Access Compliance Report Public Rights-of-Way (Curb Ramps)

Main Street: WALLINGSFORD_RD Cross Street: KENILWORTH_DR Location: SW

ADA ID: RPRK211215143540 Ramp Type: Type 1 - Perpendicular Diagonal Initial Pass/Fail: Fail Overall Compliance: No Severity Score: 15

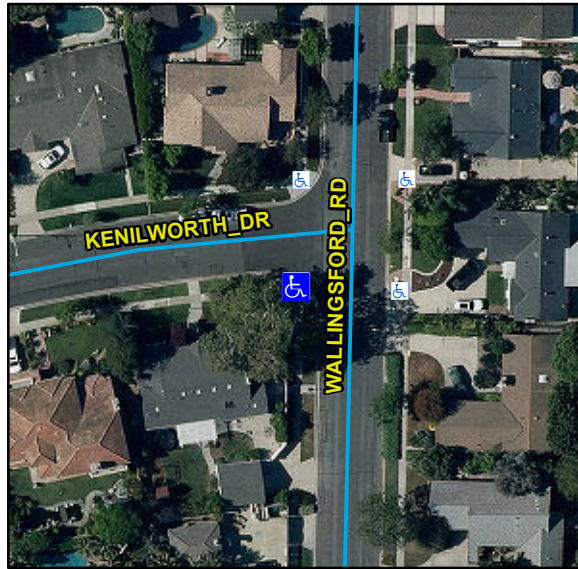
Compliance	Description	Data	Compliance	Description	Data
N/A	Ramp Length (in)	76	N/A	Flare Type LT	
Yes	Ramp Width (in)	48			N/A
No	Ramp Run Slope (%)	9.3	N/A	Flare Slope LT (%)	N/A
Yes	Ramp Cross Slope (%)	0.1	N/A	Flare Traversable LT	N/A
N/A	Landing Present	N/A	N/A	Flare Type RT	
N/A	Landing Length (in)	N/A			N/A
N/A	Landing Width (in)	N/A	N/A	Flare Slope RT (%)	N/A
N/A	Landing Run Slope (%)	N/A	N/A	Flare Traversable RT	N/A
N/A	Landing Cross Slope (%)	N/A	N/A	DWS Provided	N/A
N/A	Landing Movement Obstructed?	N/A	N/A	DWS Contrast	N/A
	Landing Movement Type	N/A	N/A	DWS Length (in)	N/A
N/A	Landing Shared	N/A	N/A	DWS Full Width	N/A
N/A	Clear Space	Yes	N/A	DWS Offset Left (in)	N/A
N/A	Clear Space To Crosswalk (in)	N/A	N/A	DWS Offset Right (in)	N/A
N/A	Marked Crosswalk 1	No	N/A	Marked Crosswalk 2	No
	Crossing 1 Direction	E		Crossing 2 Direction	N
	Marked Crosswalk 1 Width (in)	N/A		Marked Crosswalk 2 Width (in)	N/A

N/A	Ramp Inside Crosswalk 1	N/A	Yes	Ramp Inside Crosswalk 2	N/A
	Crossing 1 Slope (%)	5.6		Crossing 2 Slope (%)	7
	Crossing 1 Cross Slope (%)	0.7		Crossing 2 Cross Slope (%)	1.7
N/A	Gutter Ponding	N/A	N/A	Curb Slope	4.2
Yes	Gutter Lip Height (in)	0		Road Run Slope (%)	3
N/A	Gutter Run Slope (%)	N/A		Road Cross Slope (%)	3
N/A	Gutter Cross Slope (%)	N/A			
Yes	Overall Surface Condition: Acceptable		No	Perp Joint Present	No
	Cross Gutter Present?	No		Spandrel Present?	No
	Replace Cross Gutter?	N/A		Replace Spandrel?	N/A

Remove & Replace Curb Ramp With Two New Directional Ramps or Equivalent.
